TOWN OF MILFORD, NEW HAMPSHIRE  
OFFICE OF COMMUNITY DEVELOPMENT

## **STAFF MEMO**

**Date:** August 13, 2021  
**To:** Town of Milford Planning Board  
**From:** Jason Cleghorn, Town Planner  
**Subject:** **SD2021-09 San-Ken Homes and Rokeh Consulting, LLC (owners/applicant), Tax Map 30, Lot 19.** Public Hearing for a Major Subdivision to divide one parcel into three lots within the Residence "A" zoning district.

SITE PLAN  
 SINGLE FAMILY HOME DEVELOPMENT  
 MAP 30, LOT 19  
 WHEELER STREET, MILFORD NH

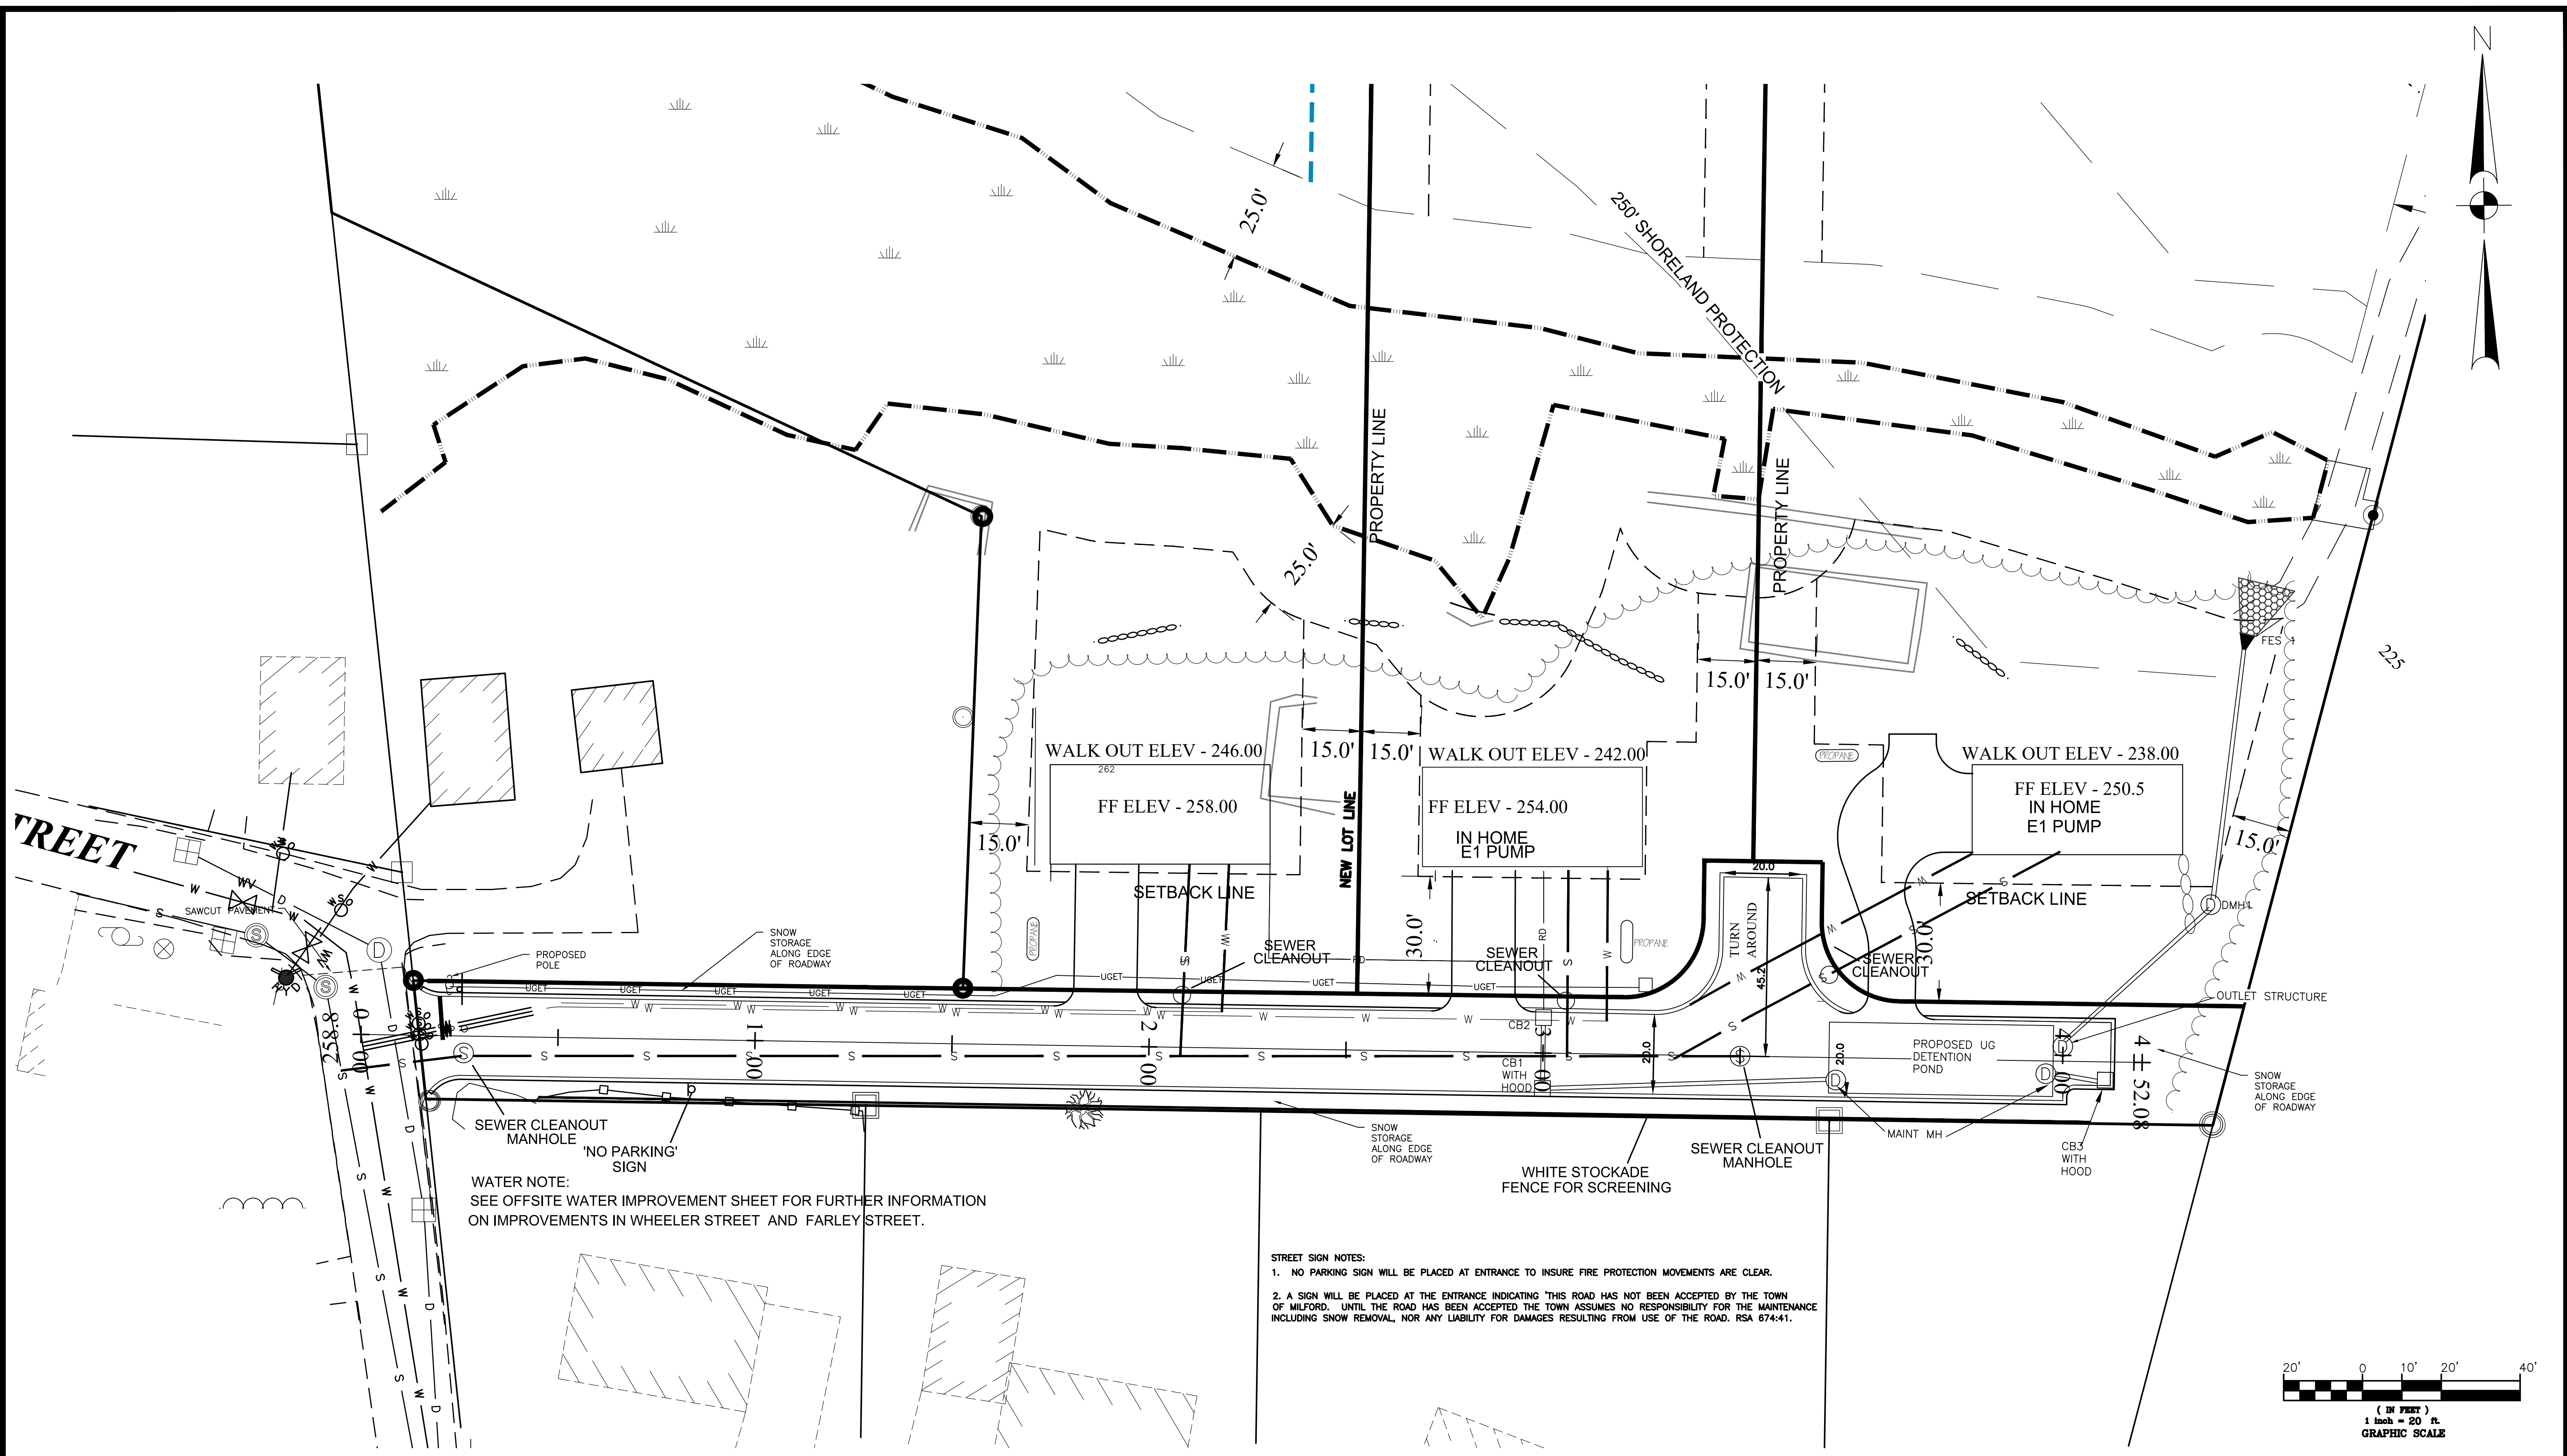
1. Discussions with DPW by Planning Staff have indicated DPW's lack of support for the waiver related to the tomahawk turnaround. Please keep Planning abreast of any discussions with Mr. Riendeau.

1. Include a turning template for the tomahawk in its current iteration showing which types of vehicles can make the turn.
2. The town will need easement documents for roadway, water and sewer. The water and sewer easement documents will allow the Town to work in those areas. There also need to be documents drawn for the HOA or property owner's maintenance of the roadway and drainage system since the Town will not maintain these entities. Easements with Eversource will also be needed for power.
3. A local stormwater permit needs to be applied for this project beyond this submittal. KV Partners will also review this.

DATE	DESCRIPTION	DWN BY	CK BY
7-21-21	EXPAND HAMMERHEAD / ADD NO PARKING SIGN	JR	JR
8-9-21	REVISED PER TOWN COMMENTS	JR	JR
